STATE OF NORTH CAROLINA
DEPARTMENT OF TRANSPORTATION

Subject: **Information to comply with Section 401 conditions** for US 401 widening from SR 2044 (Ligon Mill Rd) to north of SR 2226 (Jonesville Rd), Wake County, Federal Aid No. STP-401(4), State Project No. 81403001, WBS 34506.1.1, Division 5, TIP R-2814 A.

Reference: Section 404 Individual Permit, issued July 14, 2009, USACE Action ID 2008-01316
Section 401 Individual Water Quality Certification, Isolated Wetlands Permit and Neuse Riparian Buffer Authorization issued June 16, 2009, NCDENR-DWQ Water Quality Certification Project No. 20090104 ver.1

Rev. 7/8/10
Permit Drawing
Sheet 12 of 15

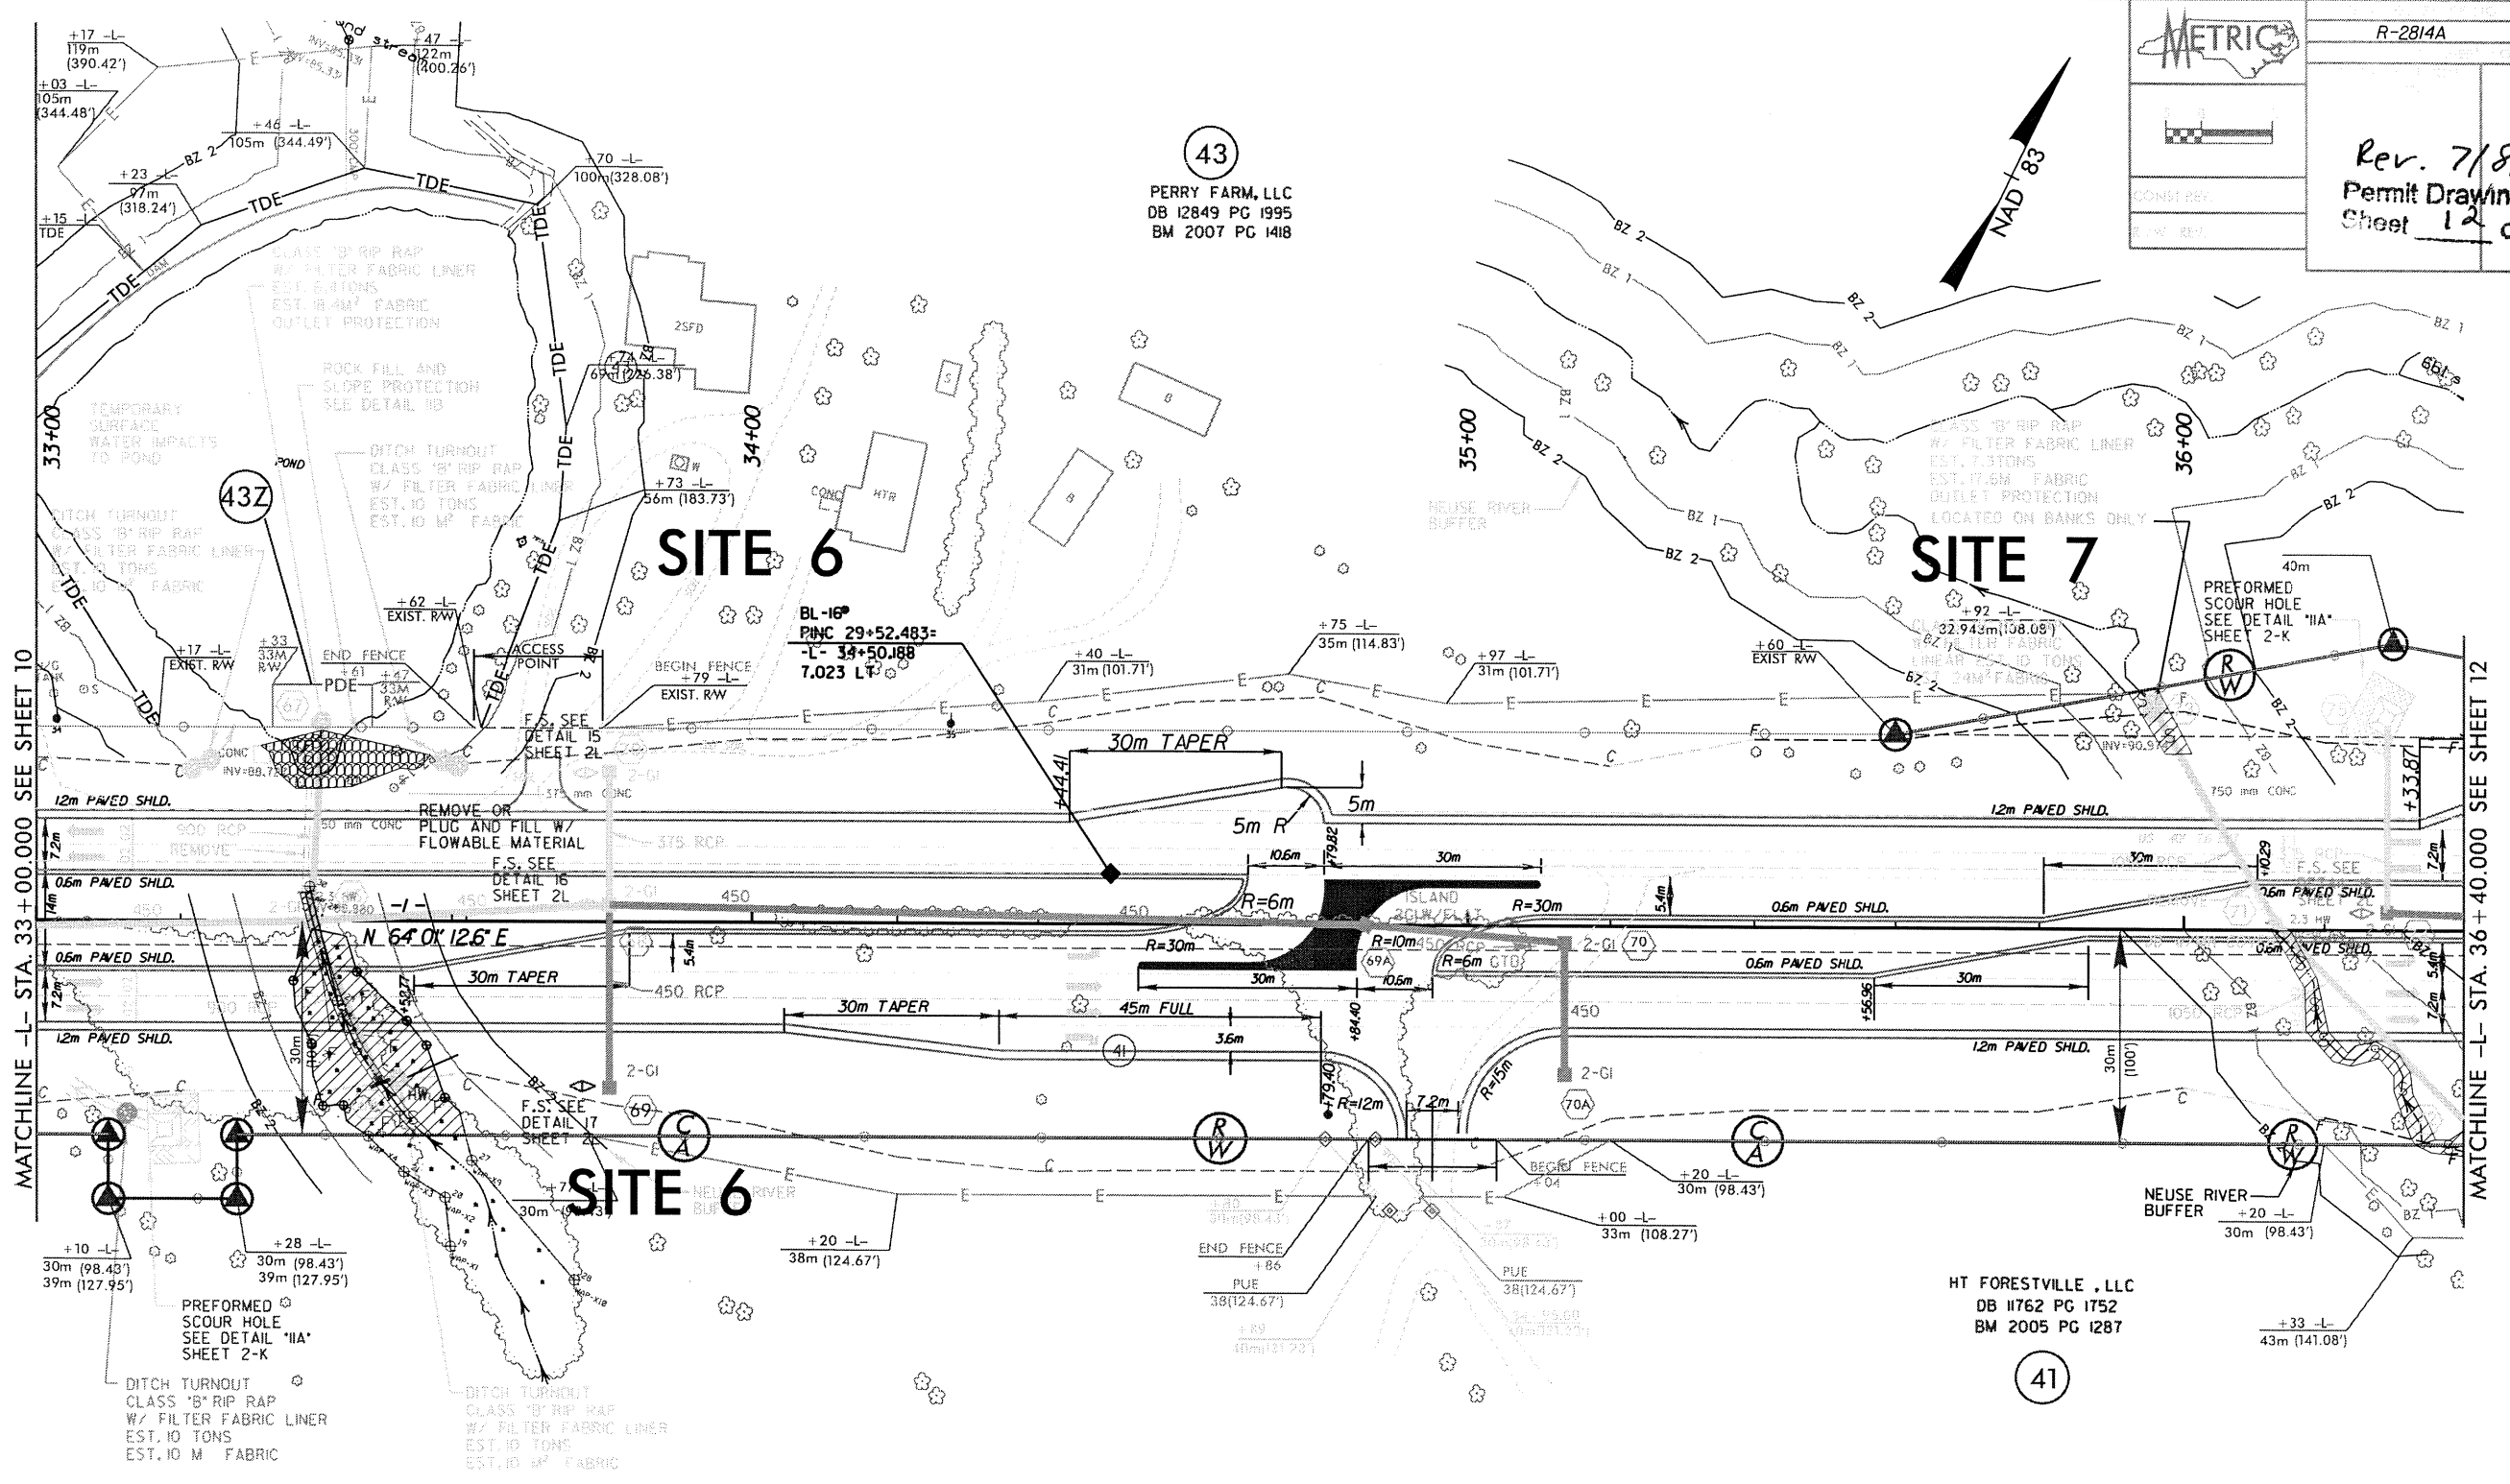
Issue: Construction plan sheet 11 and buffer permit drawing 8 depict a ditch with no liner information at the high end of a pre-formed scour hole (PFSH) located at 33+15 Rt. Stream permit drawings 12 and 13 depict rip rap in the ditch at the high end of the PFSH.

Issue: Stream permit drawings 12 and 13 depict a rip rap blob in the stream at the outlet of a 1050 mm pipe structure at 35+95 Lt. Buffer permit drawing 8 depicts no rip rap blob in the stream at the outlet of this 1050 mm pipe structure. Construction plan sheet 11 depicts a rip rap blob in the

Issue: The hydro drainage design is not consistent between the construction plan sheets, buffer permit drawings and stream permit drawings at the following locations: 33+40 to 35+15 Rt/Lt, 36+29 to 36+90 Rt/Lt and 37+50 to 39+40 Rt/Lt.

Issue: A headwall has been designed to be installed at the inlet of a 900 mm pipe structure at Station 33+45 Rt.

Response: Revised construction plan sheet 11 and revised buffer permit drawing 8 reflect rip rap in the ditch at the high end of the PFSH as depicted on stream permit drawings 12 and 13.

Response: Revised stream permit drawings 12 and 13 and revised buffer permit drawing 8 reflect a rip rap blob in the stream at the outlet of this 1050 mm pipe structure with a note directing that outlet protection be located on banks only at this location as depicted on construction plan sheet 11.

Response: Revised construction plan sheets 11 and 12, revised stream permit drawings 12, 13, 14 and 15, and revised buffer permit drawings 8 and 9 reflect the revised hydro design.

Response: This construction revision has been depicted on revised construction plan 11, revised stream permit drawings 12 and 13, and revised buffer permit drawing 8.

PROJECT REFERENCE NO.	R-2814A	SHEET NO.	6
DESIGNER	VBBSS GROUP, LLC		
DATE	REV. 7/8/10		
Buffer Drawing			
Sheet 6 of 9

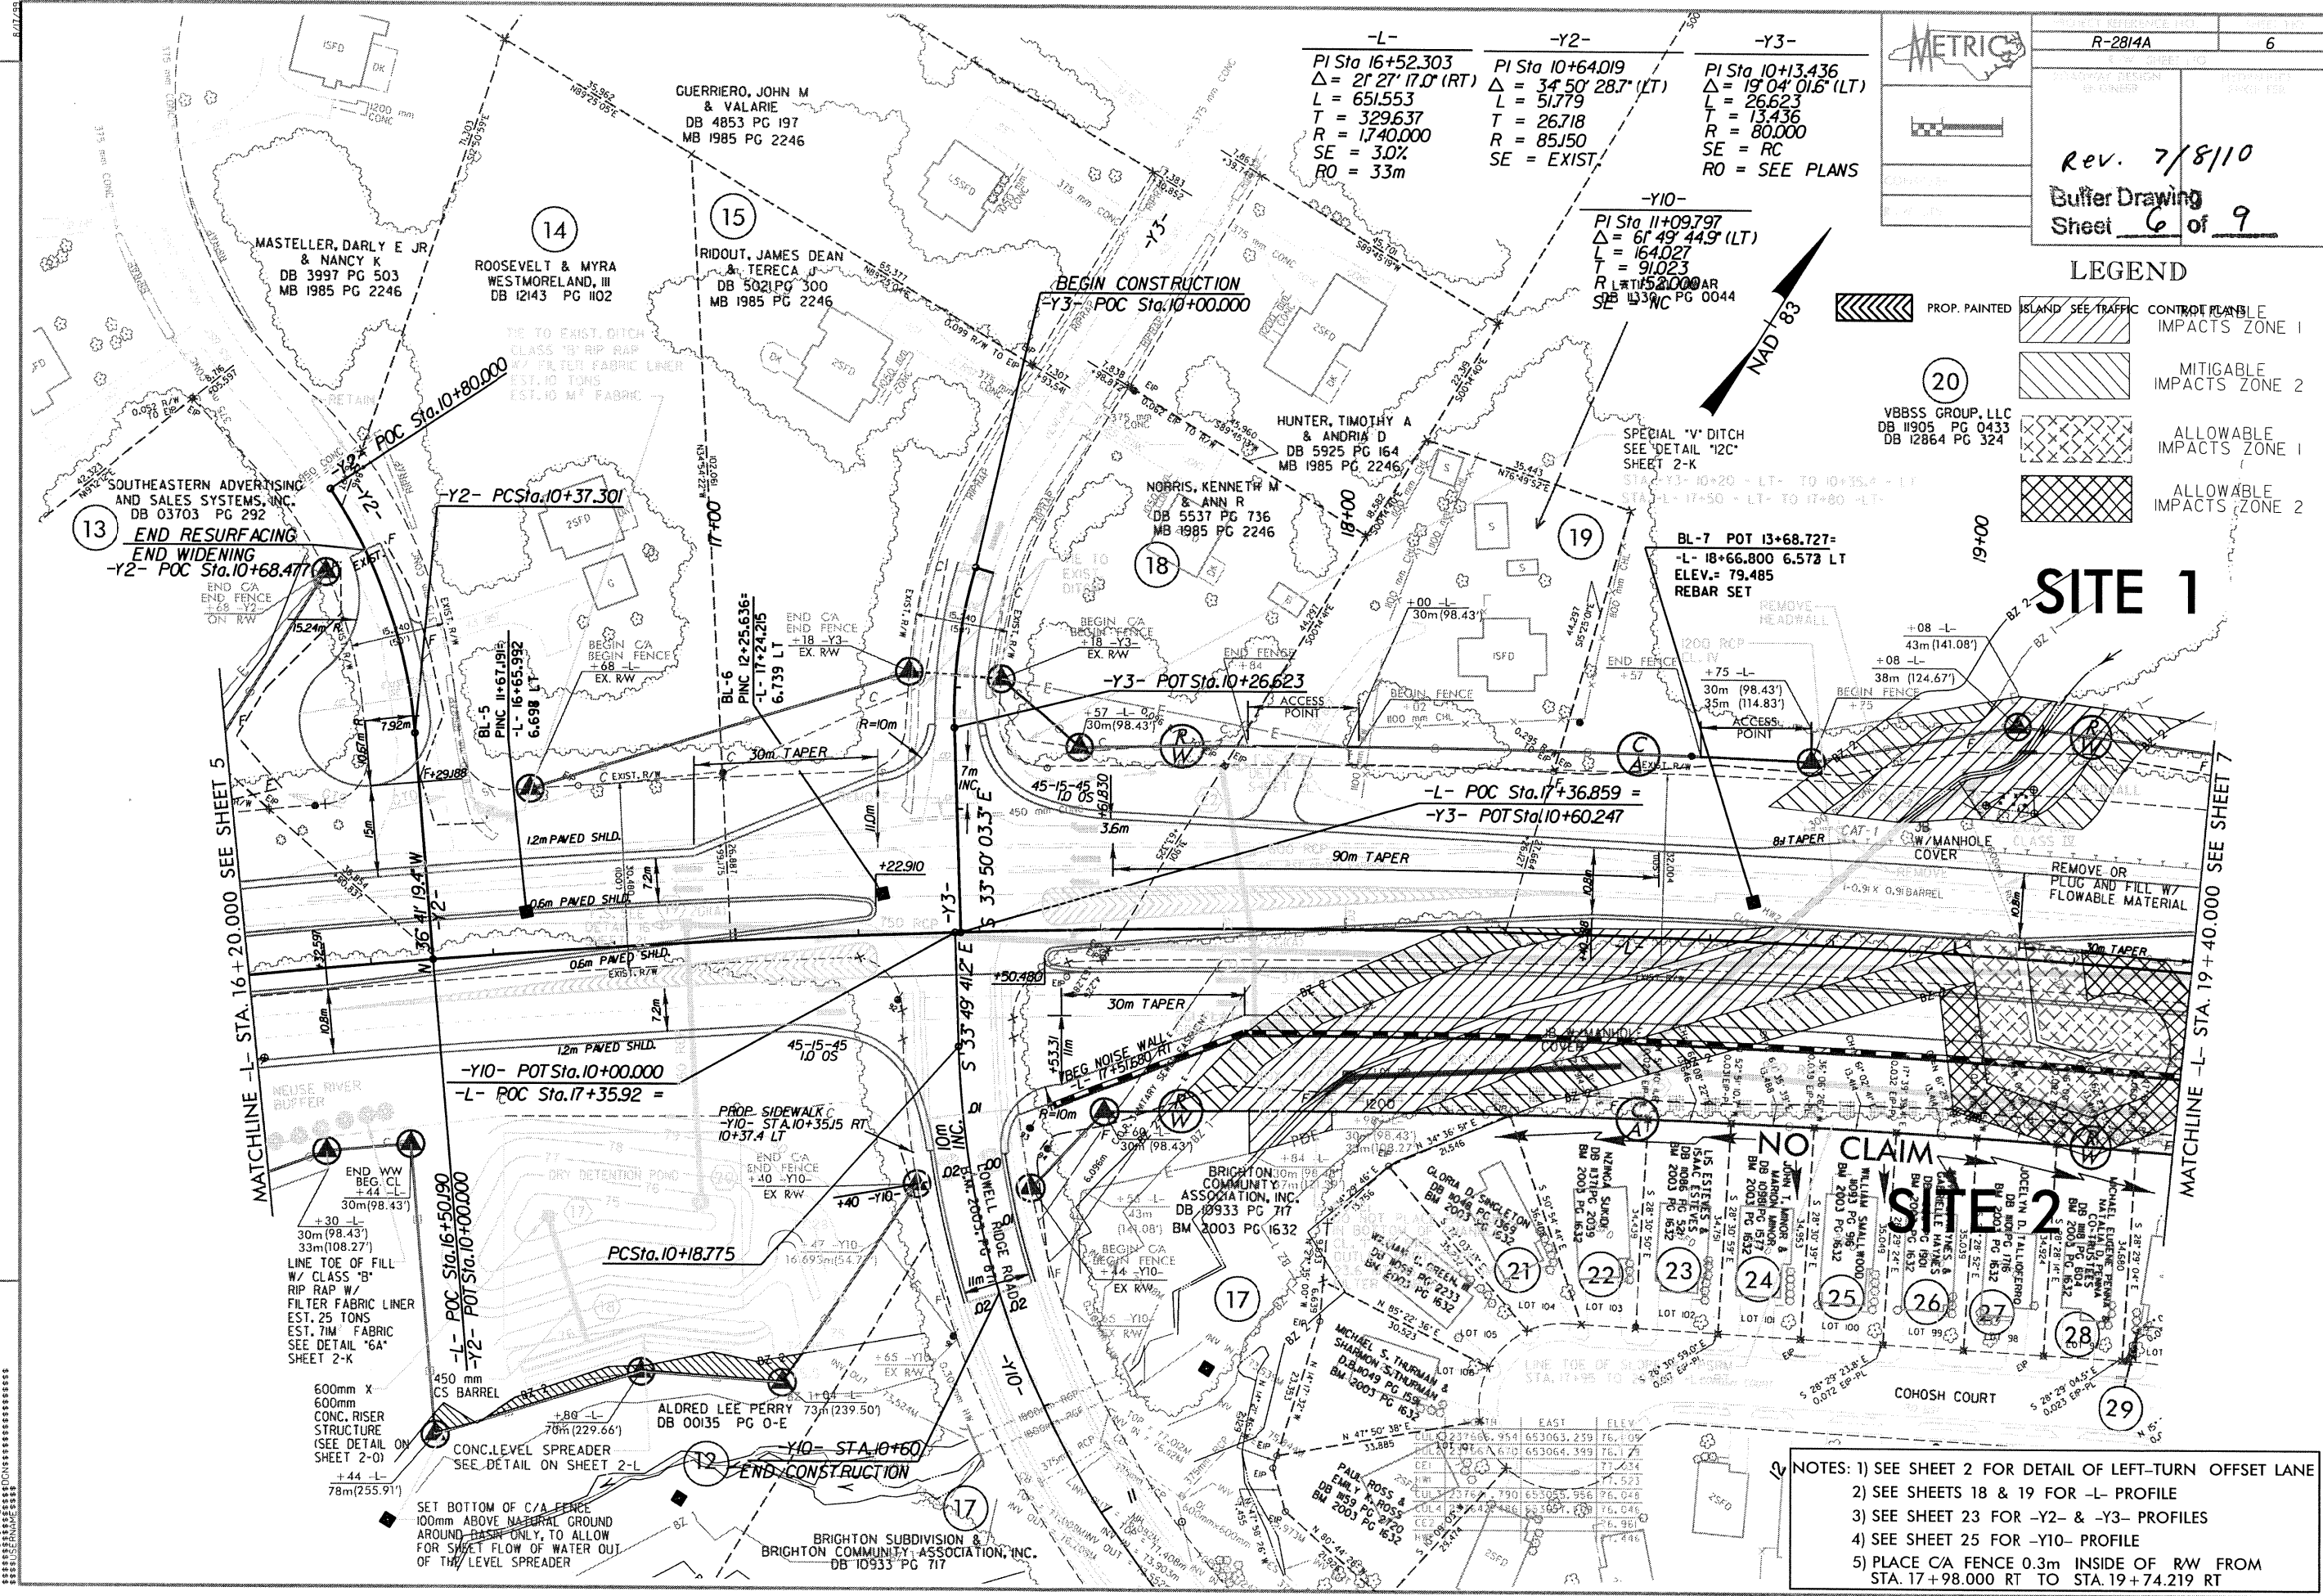
Issue: Stream permit drawings 10 and 11 and buffer permit drawing 6 depict a jurisdictional stream at the inlet and outlet of a 600 mm pipe structure at 19+00 to 19+30 Lt/Rt. However, a review of construction plan sheet 6 does not depict any stream or channel feature at this location.

Issue: Stream permit drawings 10 and 11 and buffer permit drawing 6 depict a 400 mm pipe structure that conveys runoff from the dry detention pond to the level spreader device at 16+65 Rt. However, a review of construction plan sheet 6 indicates that this is a 450 mm pipe structure at this location.

Issue: Stream permit drawings 10 and 11 and buffer permit drawing 6 depict construction of a headwall in a 1200 mm pipe (conveying a jurisdictional stream) that is skewed to the toe of fill at 19+10 Lt. However, a review of construction plan sheet 6 indicates that the headwall at this location is parallel to the toe of fill.

Response: Revised construction plan 6 reflects the jurisdictional stream depicted on stream permit drawings 8 and 9 and buffer permit drawing 6.

Response: Revised stream permit drawings 10 and 11 and revised buffer permit drawing 6 reflect the 450 mm pipe structure that conveys runoff from the dry detention pond to the level spreader as depicted on construction plan 6.

Response: Revised stream permit drawings 10 and 11 and revised buffer permit drawing 6 reflect the headwall parallel to the toe of fill as depicted on construction plan 6.
